Cover Page 1142 Pittwater Road Collaroy NSW 2097 - Proposed Alterations & Additions

PROJECT
Proposed Alterations & Additions

DRAWING NUMBER
S4.55-00
ISSUE
C

Proposed Raised Roof Plan
1:100

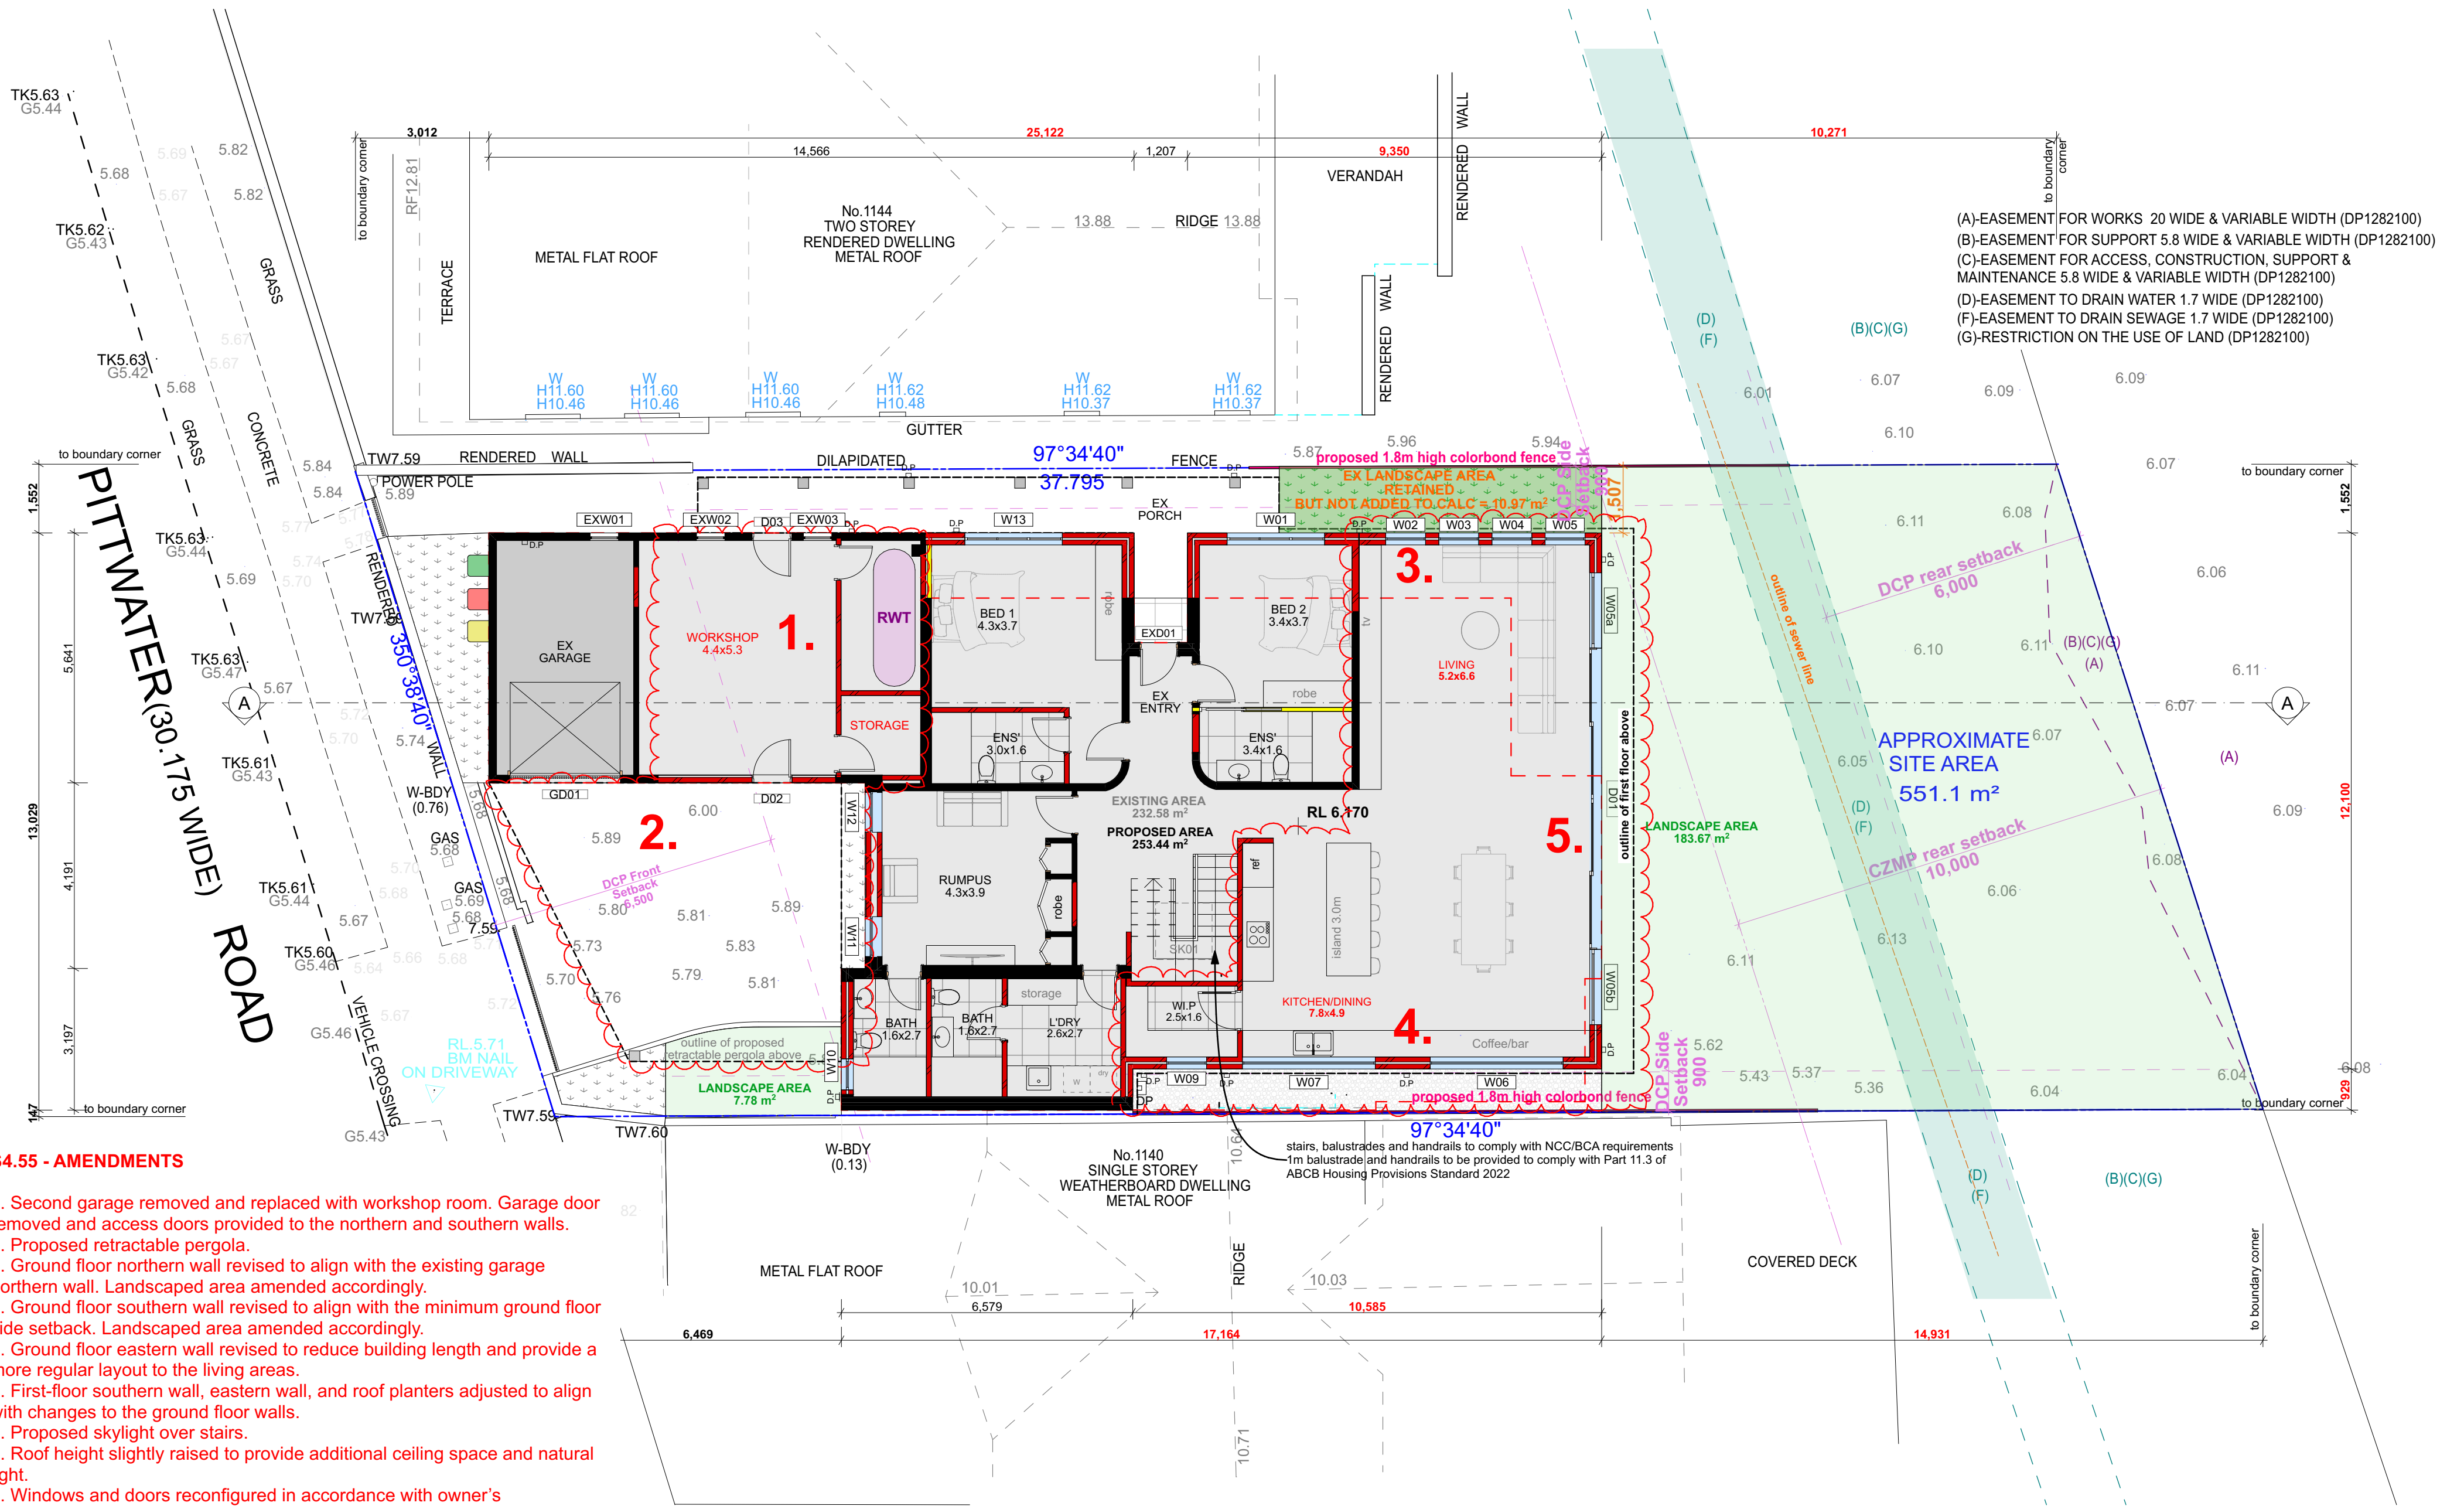
2.

8.

7.

1. Second garage removed and replaced with workshop room. Garage door removed and access doors provided to the northern and southern walls.
2. Proposed retractable pergola.

3. Ground floor northern wall revised to align with the existing garage northern wall. Landscaped area amended accordingly.
4. Ground floor southern wall revised to align with the minimum ground floor side setback. Landscaped area amended accordingly.

5. Ground floor eastern wall revised to reduce building length and provide a more regular layout to the living areas.
6. First-floor southern wall, eastern wall, and roof planters adjusted to align with changes to the ground floor walls.

7. Proposed skylight over stairs.
8. Roof height slightly raised to provide additional ceiling space and natural light.
9. Windows and doors reconfigured in accordance with owner's requirements (refer to external window & door schedules).

Proposed Ground Floor Plan
1:100

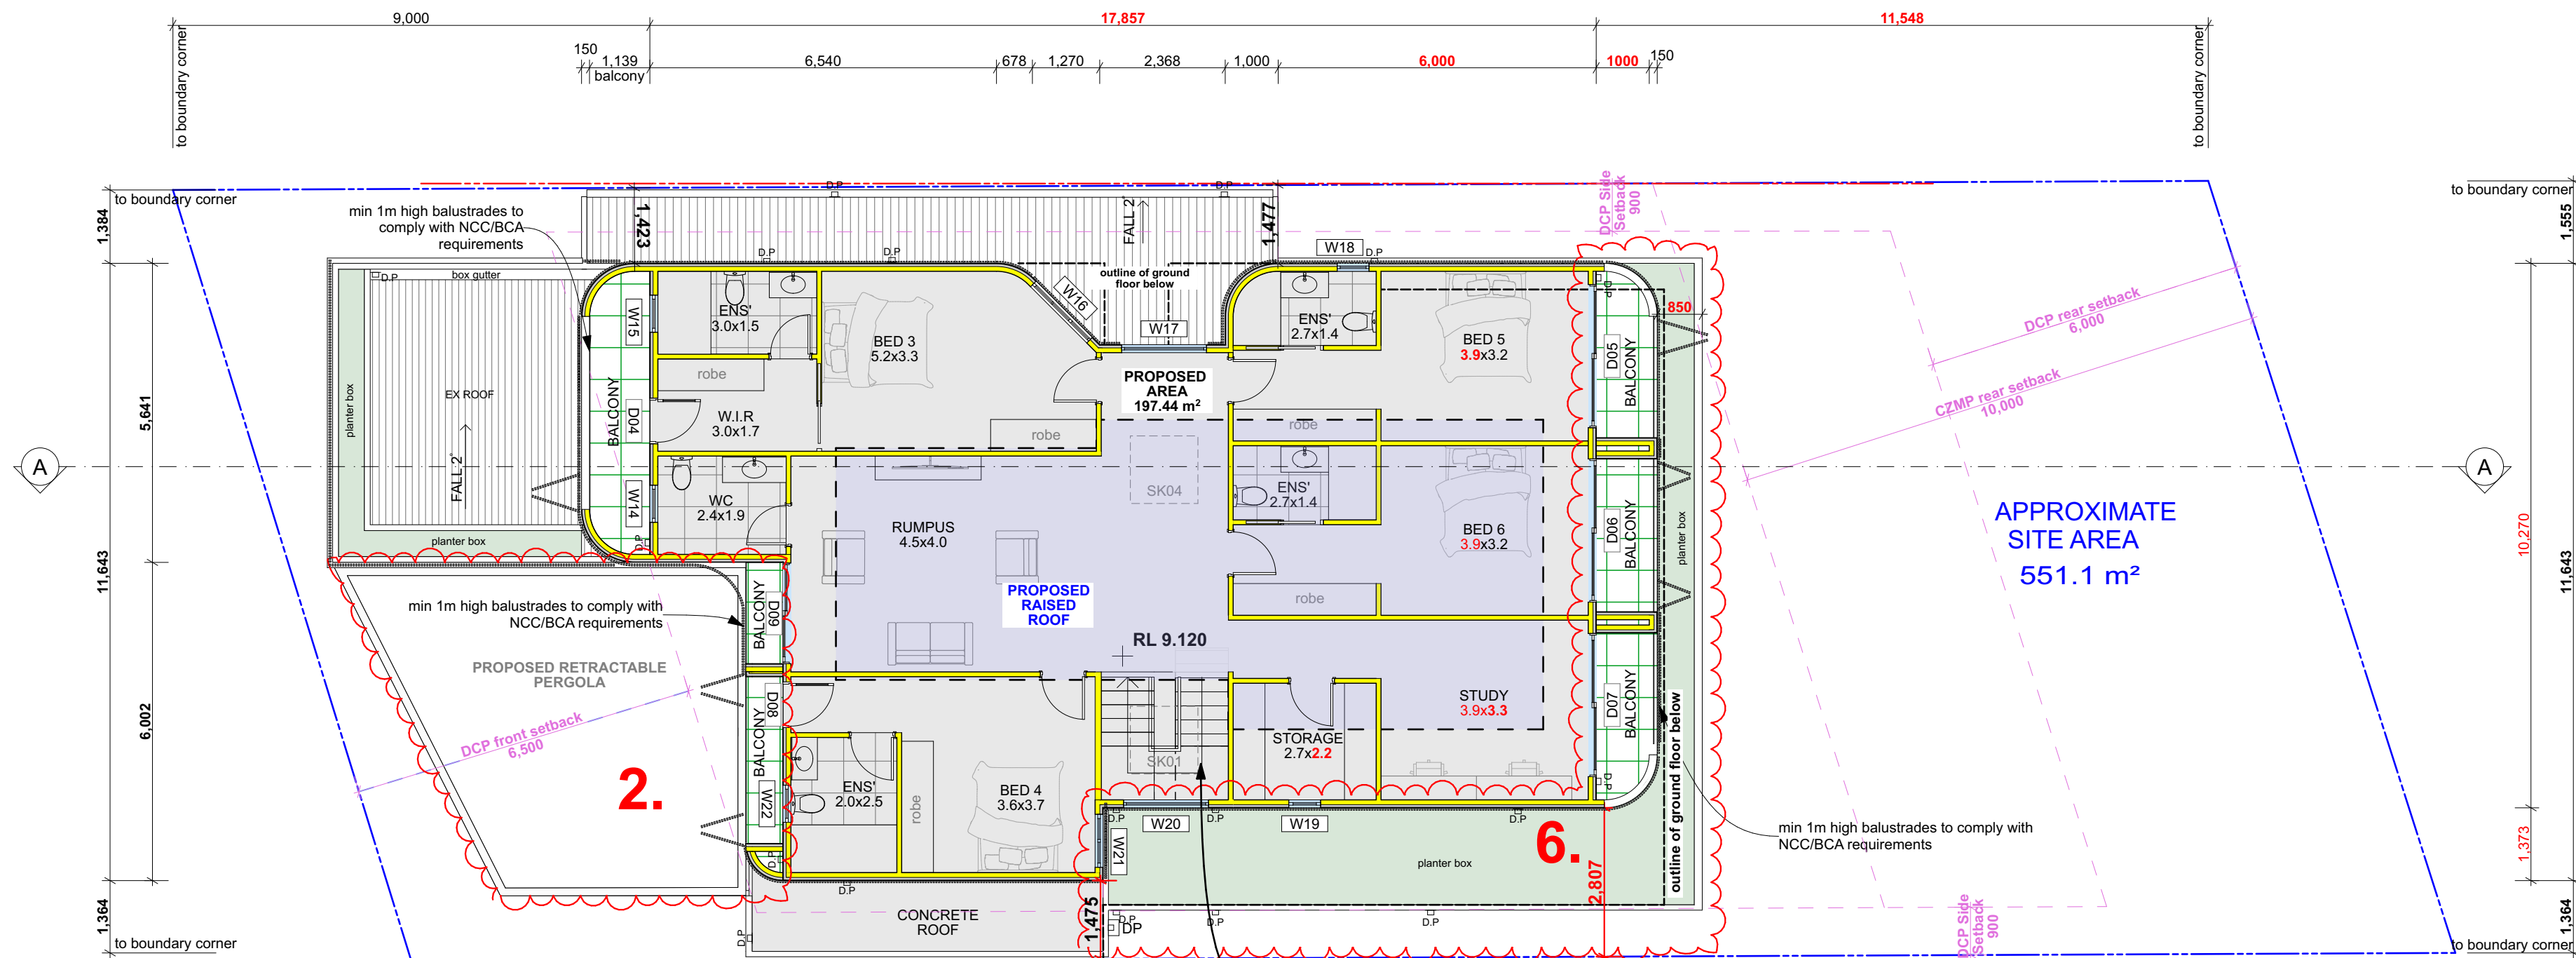
1. Second garage removed and replaced with workshop room. Garage door removed and access doors provided to the northern and southern walls.
2. Proposed retractable pergola.

3. Ground floor northern wall revised to align with the existing garage northern wall. Landscaped area amended accordingly.
4. Ground floor southern wall revised to align with the minimum ground floor side setback. Landscaped area amended accordingly.

5. Ground floor eastern wall revised to reduce building length and provide a more regular layout to the living areas.
6. First-floor southern wall, eastern wall, and roof planters adjusted to align with changes to the ground floor walls.

Proposed First Floor Plan
1:100

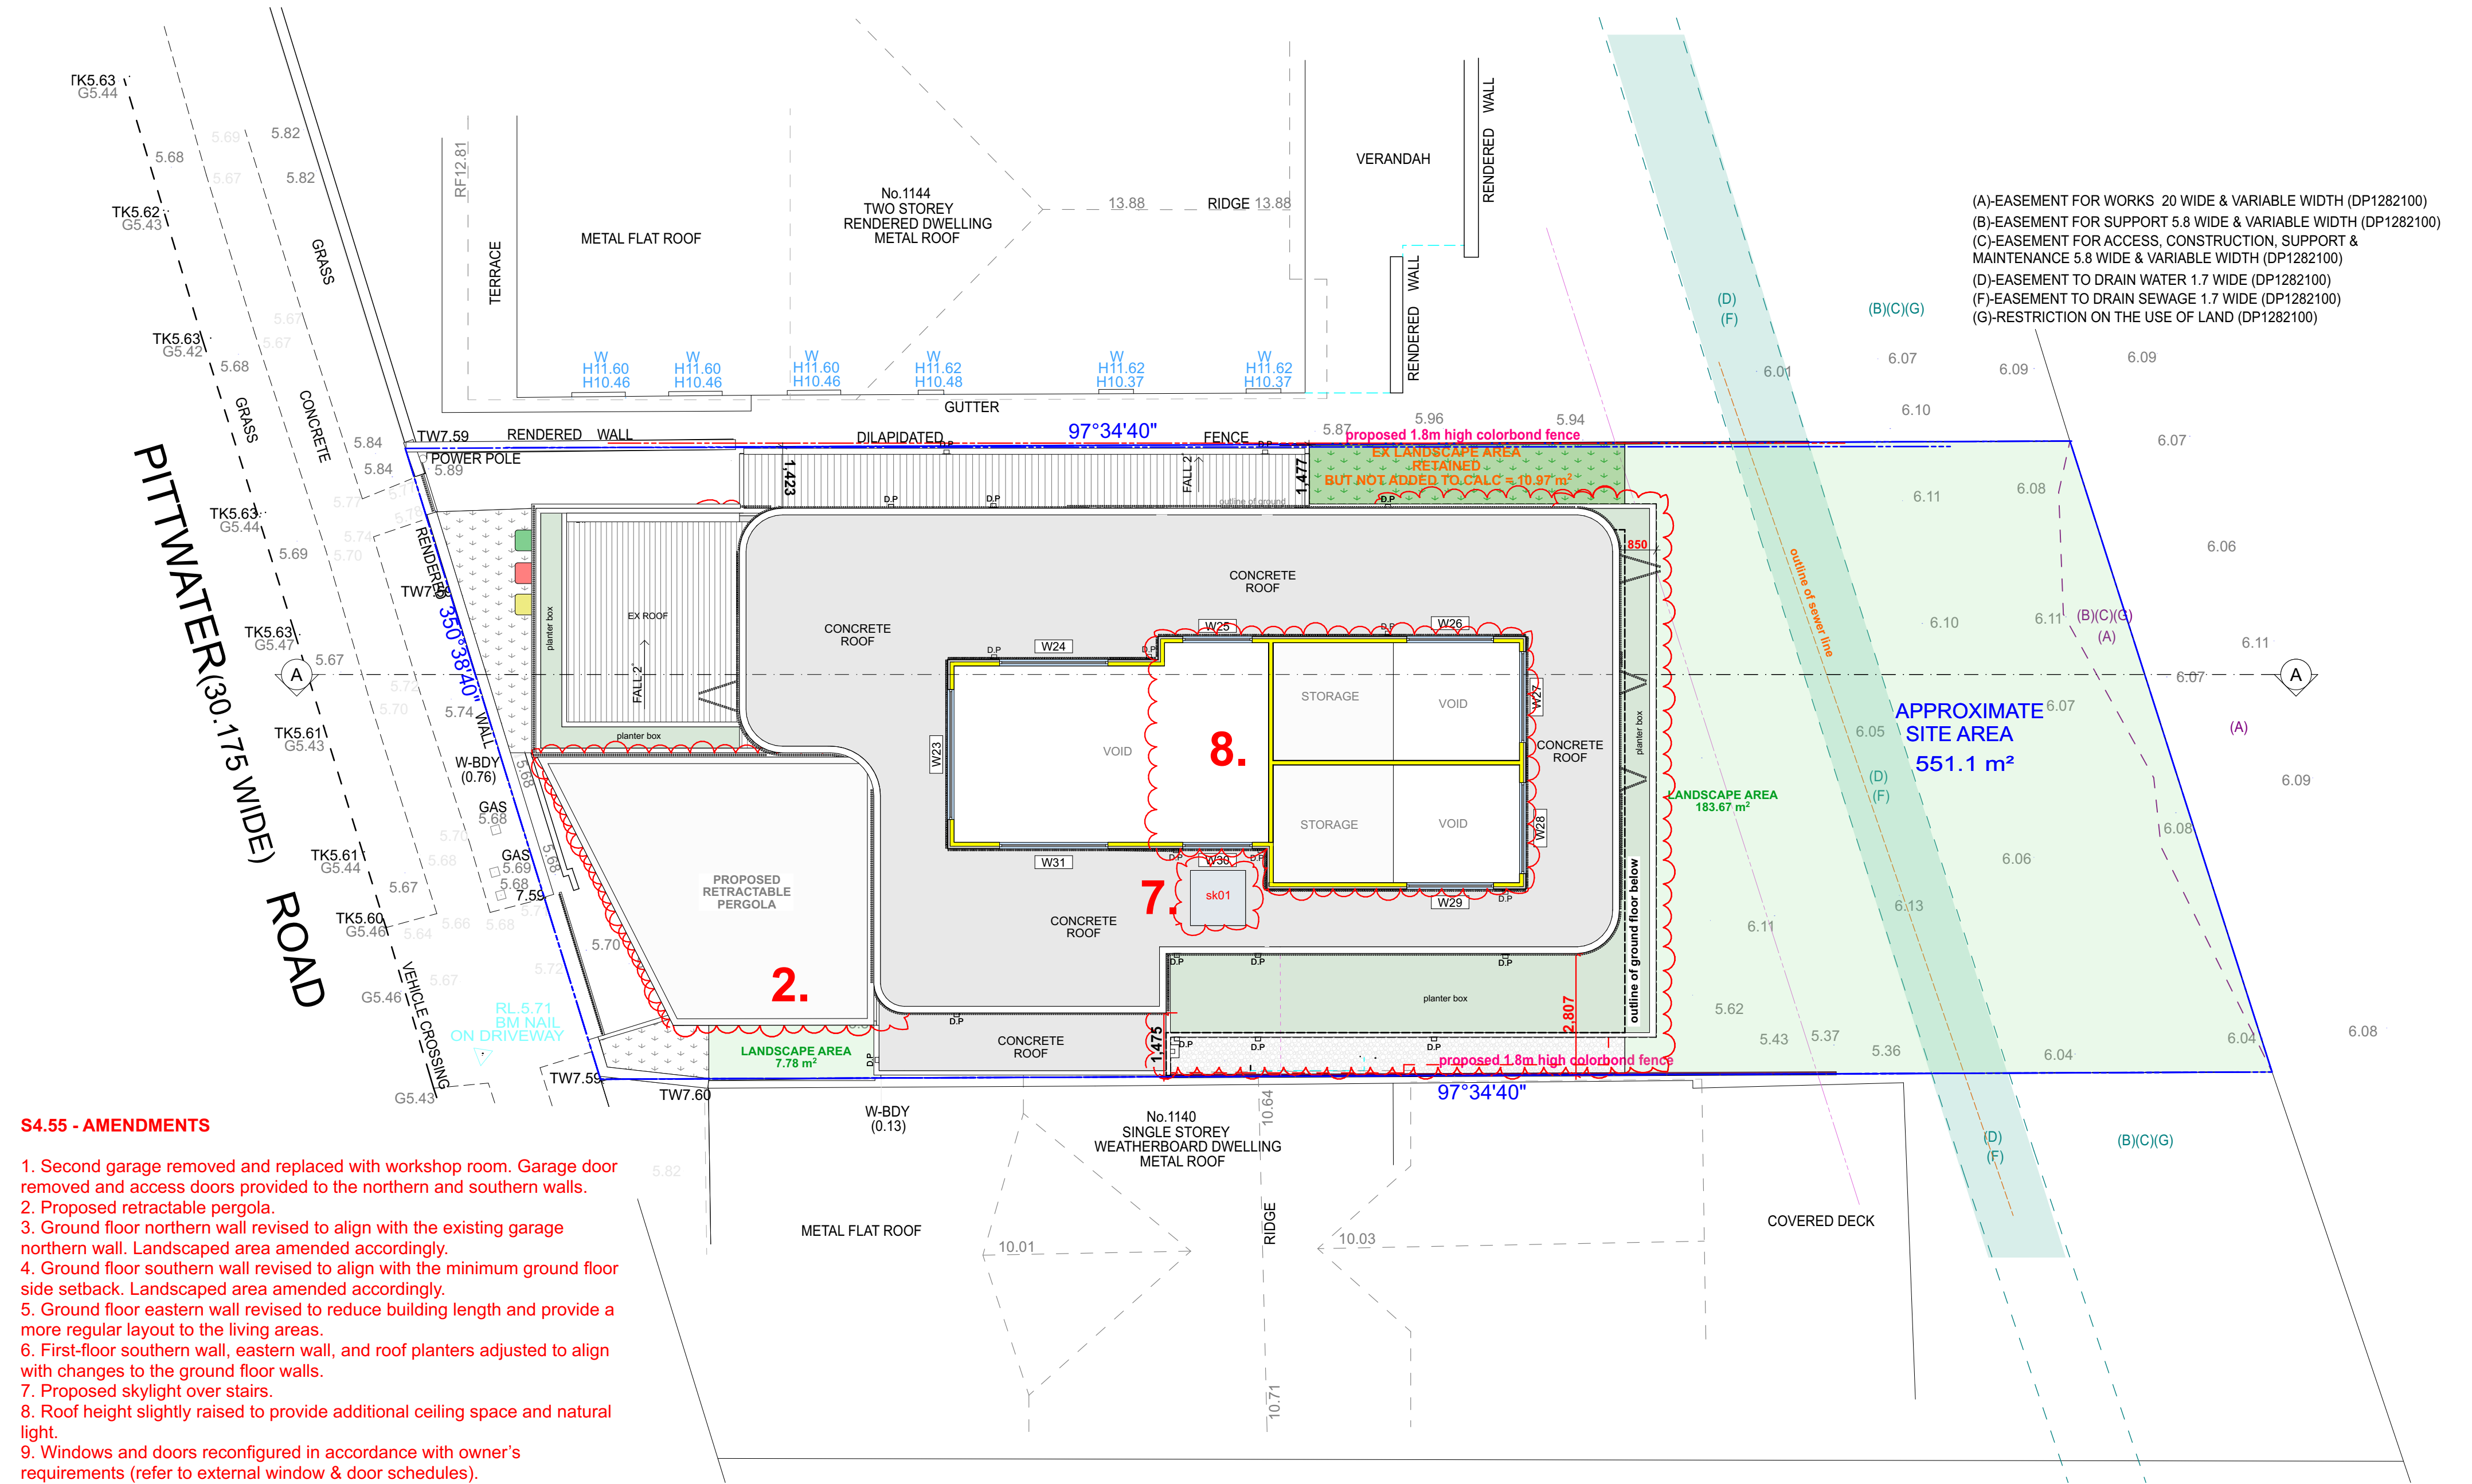
1. Second garage removed and replaced with workshop room. Garage door removed and access doors provided to the northern and southern walls.
2. Proposed retractable pergola.

3. Ground floor northern wall revised to align with the existing garage northern wall. Landscaped area amended accordingly.
4. Ground floor southern wall revised to align with the minimum ground floor side setback. Landscaped area amended accordingly.

5. Ground floor eastern wall revised to reduce building length and provide a more regular layout to the living areas.
6. First-floor southern wall, eastern wall, and roof planters adjusted to align with changes to the ground floor walls.

7. Proposed skylight over stairs.
8. Roof height slightly raised to provide additional ceiling space and natural light.
9. Windows and doors reconfigured in accordance with owner's requirements (refer to external window & door schedules).
